Amendments to the Drawings:

REMARKS / ARGUMENTS

FIG-1

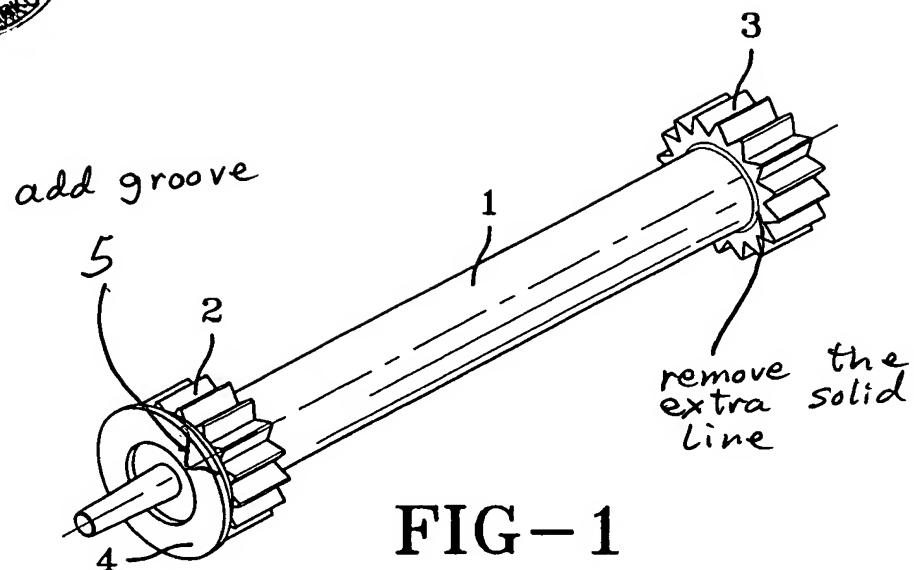
The replacement drawings for figures 1, 2, 4, 5, 6, 7, 8, 9, 10 and 11 better reflect the depth of the gear teeth. In figure 1 extraneous lines were removed and the groove reference number 5 was added with a cut out portion to show the groove 5 better. In figures 1 and 2 an unneeded line near the gear 3 was deleted. In figures 4 - 10 the trough of the gear teeth was shown as a dashed line. In figure 11 more cross hatching was added to better show the component features.

Drawing figures 1, 4, 5, 6, 7, 8, 9 and 10 have been corrected to show the trough of the gear teeth being less radially deep as compared to the circumferential groove. No new matter has been added. The corrections clarify the drawings that were objected to by the examiner. Figures 2 and 11 were also amended to provide a clearer view. Withdrawal of this rejection is respectfully requested. Replacement sheets are being filed herewith.

FIG-5

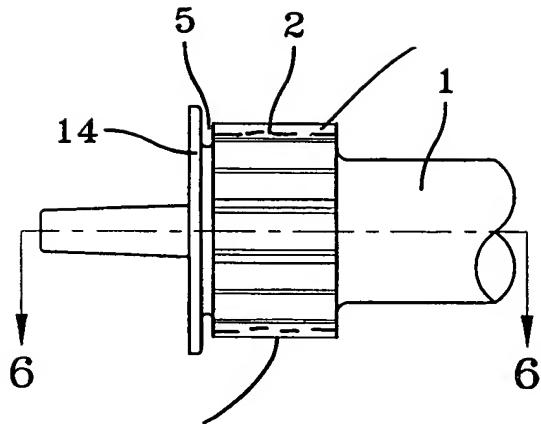
*add dashed lines to  
each of these figs to  
indicate trough of gears*

FIG-9

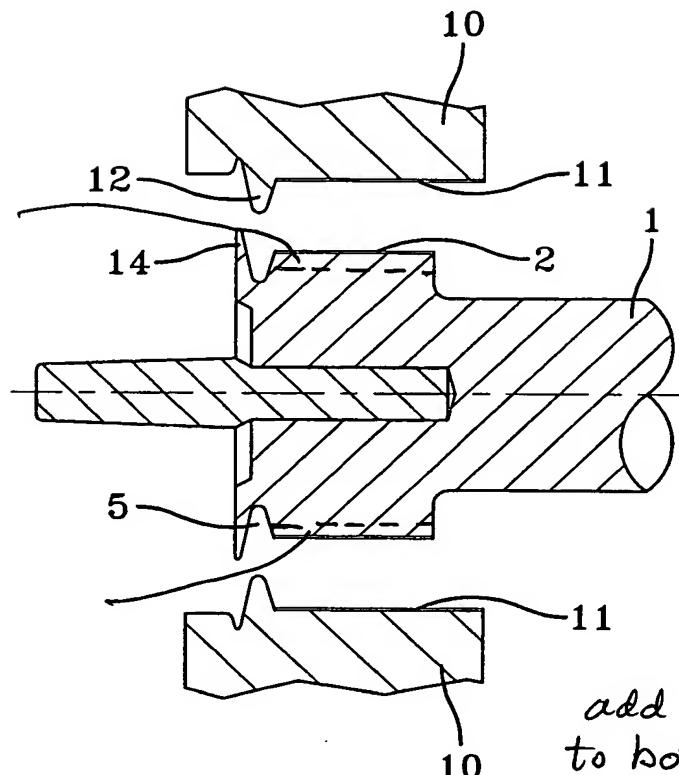
add dashed lines  
to both figs to  
indicate trough of  
gears
